# ARCHITECT'S SUPPLEMENTAL INSTRUCTIONS

<b>Project:</b>	Lumberyard District – Building 3 Omaha, NE	<b>Initiated By</b>		<b>Distributed To</b>	
<b>Project Number:</b>	15928	<input type="checkbox"/>	Owner	<input checked="" type="checkbox"/>	
<b>Owner:</b>	Lanoha Development	<input type="checkbox"/>	Architect	<input checked="" type="checkbox"/>	
<b>To Contractor:</b>	Overland Constructors 5036 South 135 <sup>th</sup> Street Omaha, NE 68145	<input type="checkbox"/>	Contractor	<input checked="" type="checkbox"/>	
		<input checked="" type="checkbox"/>	Consultant	<input checked="" type="checkbox"/>	
		<input type="checkbox"/>	Field	<input type="checkbox"/>	
		<input type="checkbox"/>	Other	<input type="checkbox"/>	
<b>Supplemental Instruction No.:</b>	005				
<b>Date:</b>	March 4, 2016				
<b>Contract Date:</b>	August 18, 2015				
<b>Contract For:</b>	New Construction				
<b>By:</b>	Holland Basham Architects

Description: Revised Fire department connection.

**1 FIRST FLOOR - PLUMBING PLAN - AREA A**

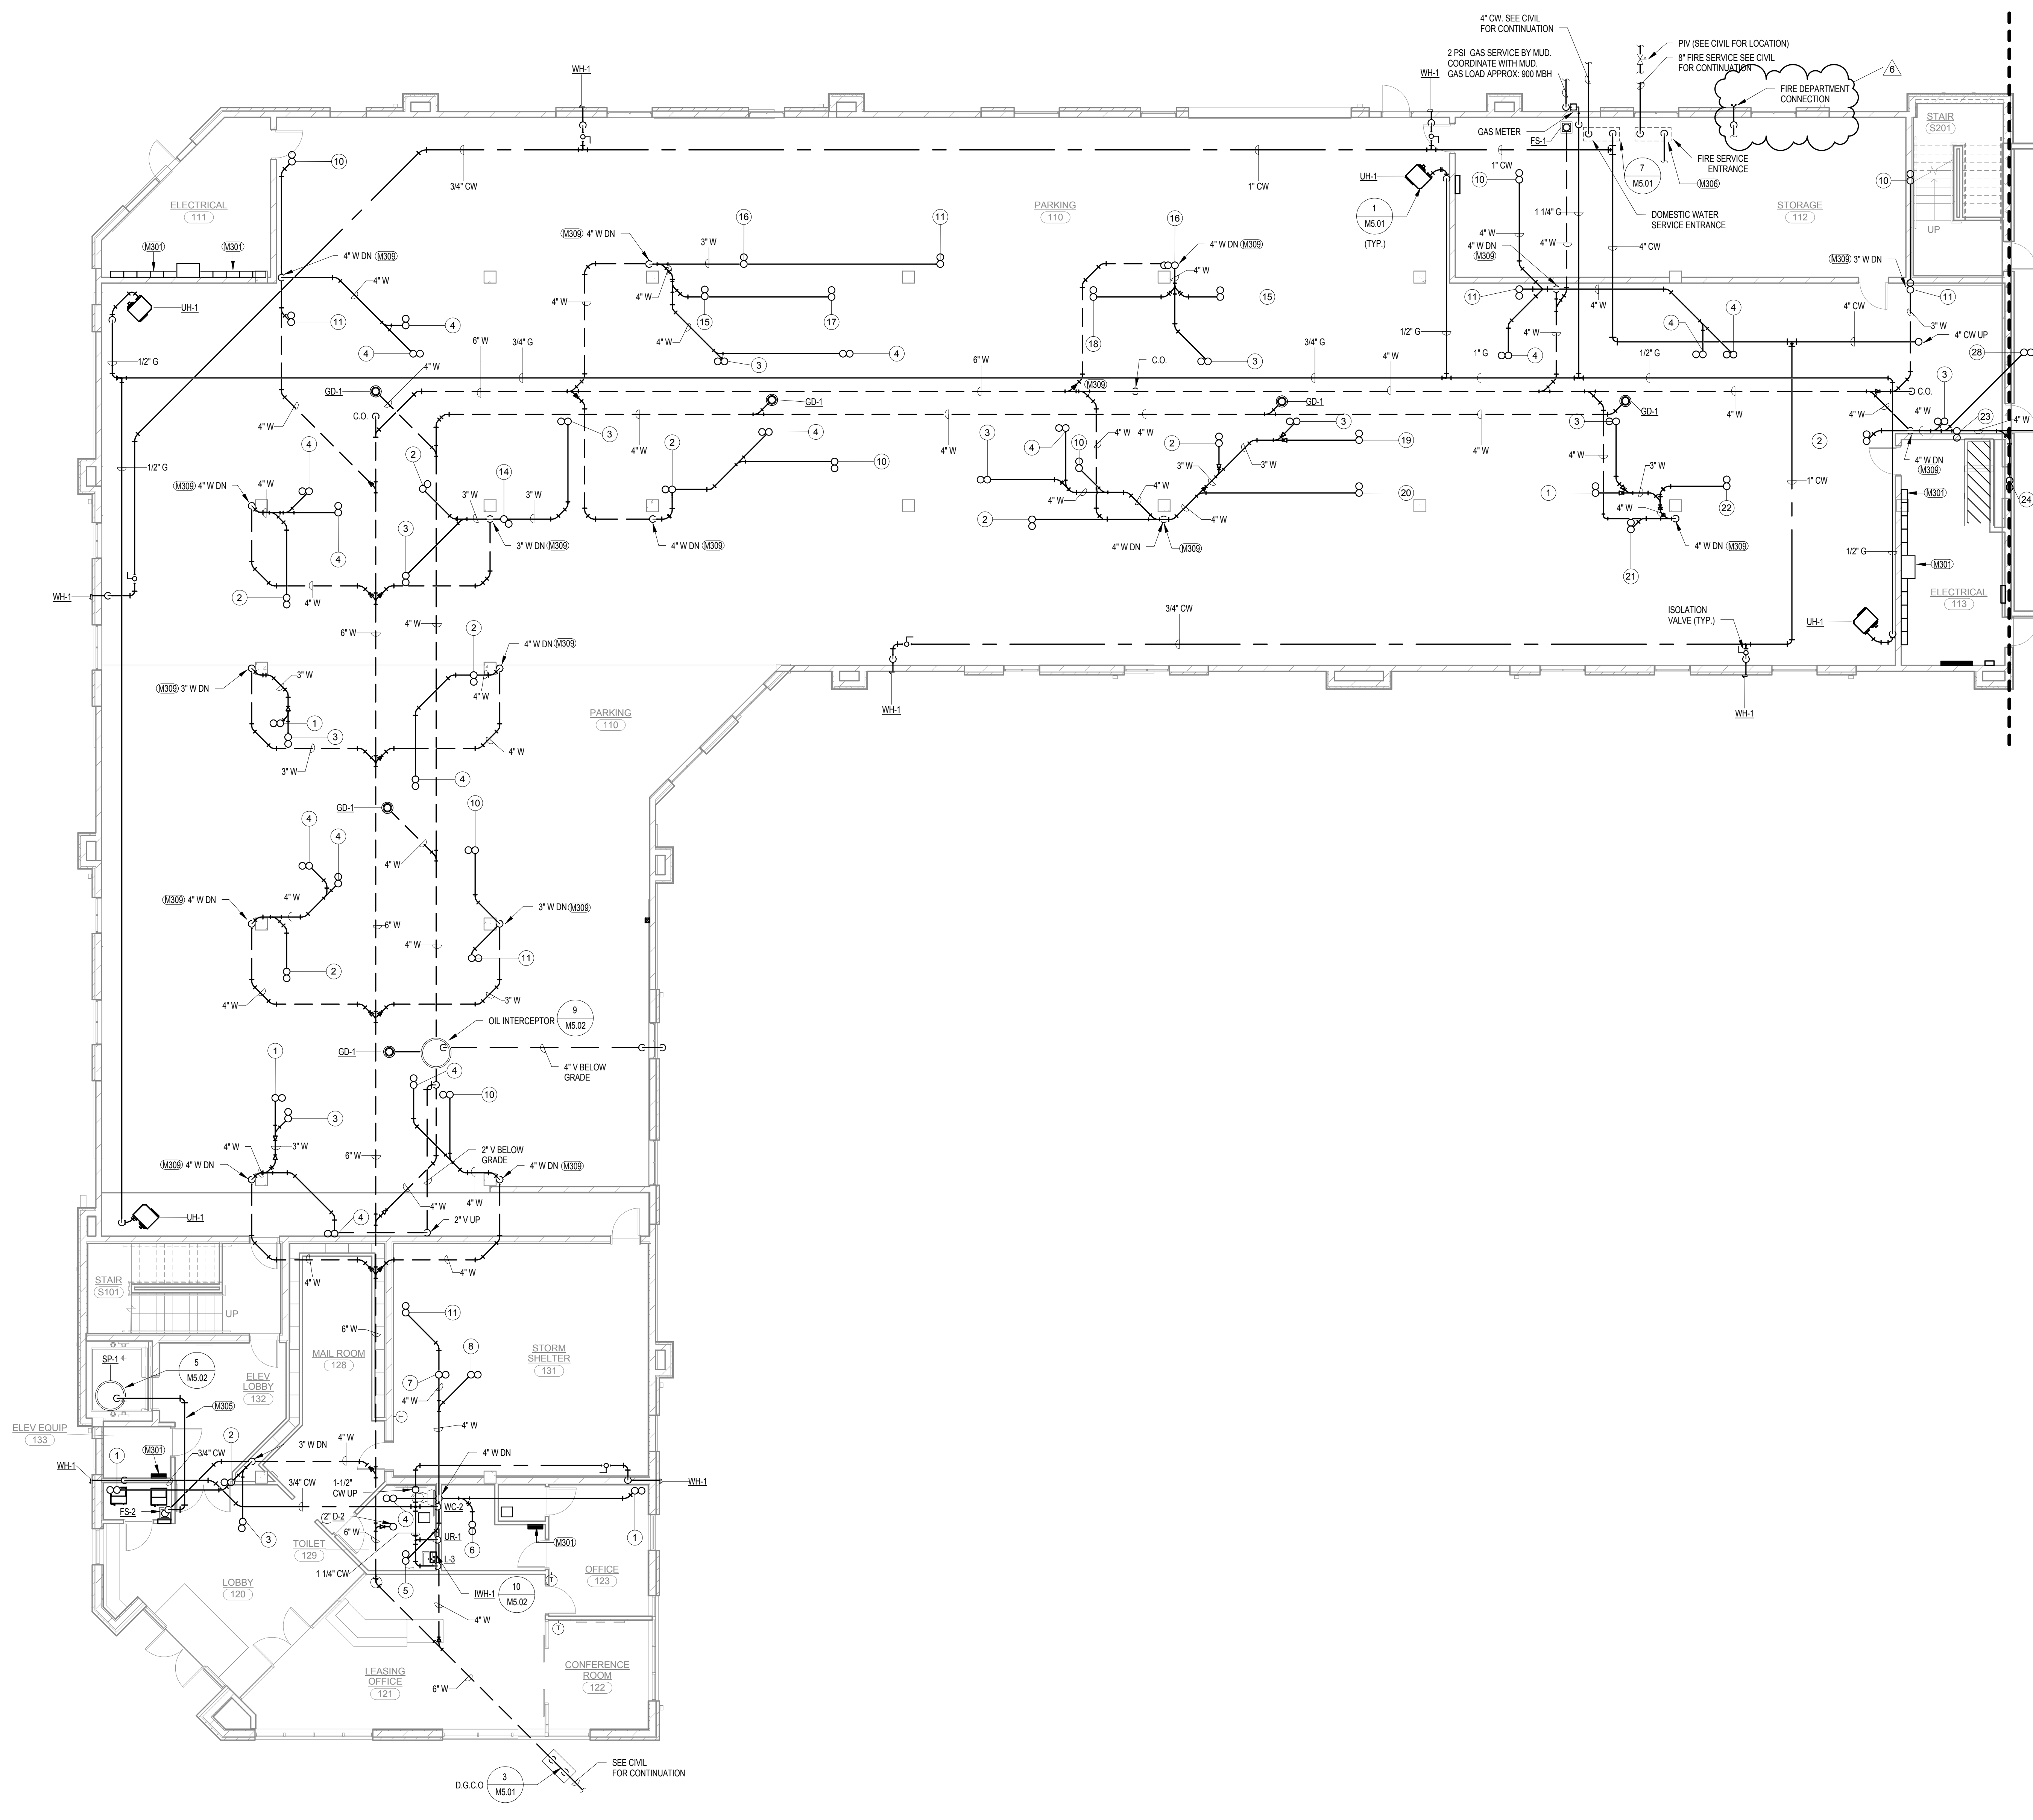
1. Sheet M2.01 – First Floor Plan – Area A - Plumbing
  - a. Add Fire department connection as shown in attached Sheet M2.01A.
